# Parcel 9: Pennrose Waiver Request & Recommendation

Pennrose / TAT / Beta

# Transparency Analysis: Building One

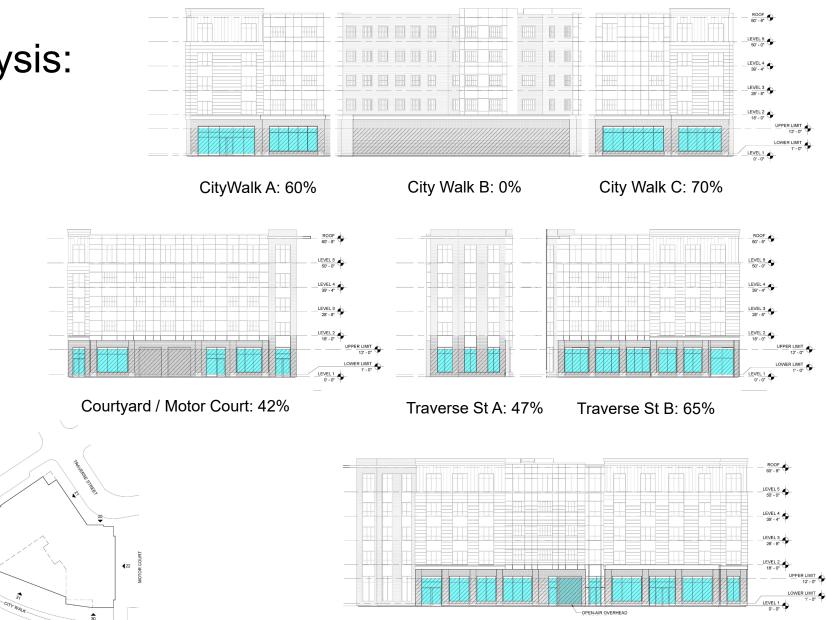
Total Achieved: 51% Requirement: 70% Suggested Waiver: 50%

Alves Way: 65%

## Waiver Request: Building One

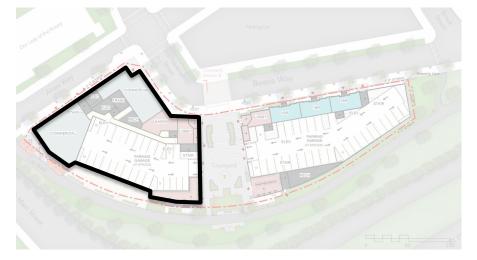
Development Plan Regulations, Section 2.5 2b Requirement: **70% transparency** for all ground-floor non-residential façades

Building One Status:51% transparency for all ground-floor non-residential façades

Justification for Waiver:

- 1. Residential Context: nearby commercial uses are minimal now and for the foreseeable future (unlike elsewhere in the District), so a more residential level of transparency is contextually appropriate.
- 2. Unique Siting: 4 public-facing facades makes it difficult to accommodate resident parking, service and back-of-house uses while maintaining transparency requirement.
- **3.** CityWalk Frontage: does not require commercial activation, intensive planting, murals and other activation is sufficient.

Total Achieved: 51% Requirement: 70% Suggested Waiver: 50%

# Transparency Analysis: Building Two

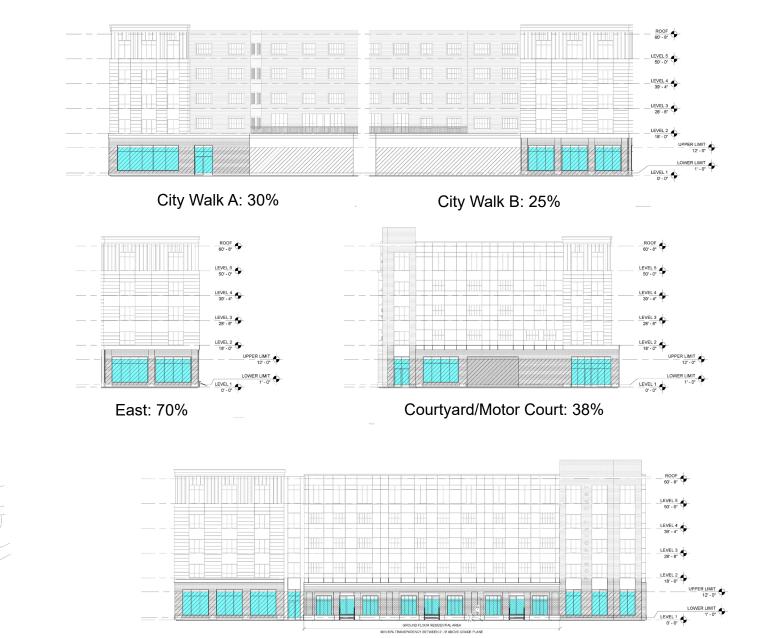
Total Achieved: 40% Requirement: 70% Suggested Waiver: 40%

Residential: 30%

Bessie Way: 60%

## Waiver Request: Building Two

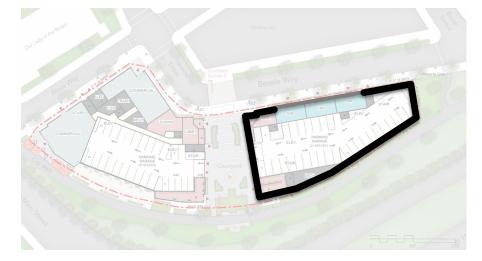
Development Plan Regulations, Section 2.5 2b Requirement: **70% transparency** for all ground-floor non-residential façades

Building Two Status:40% transparency for all ground-floor non-residential façades

Justification for Waiver:

- 1. Residential Context: nearby commercial uses are minimal now and for the foreseeable future (unlike elsewhere in the District), so a more residential level of transparency is contextually appropriate.
- 2. Unique Siting: 4 public-facing facades makes it difficult to accommodate resident parking, service and back-of-house uses while maintaining transparency requirement.
- **3.** CityWalk Frontage: does not require commercial activation, intensive planting, murals and other activation is sufficient.

Total Achieved: 40% Requirement: 70% Suggested Waiver: 40%
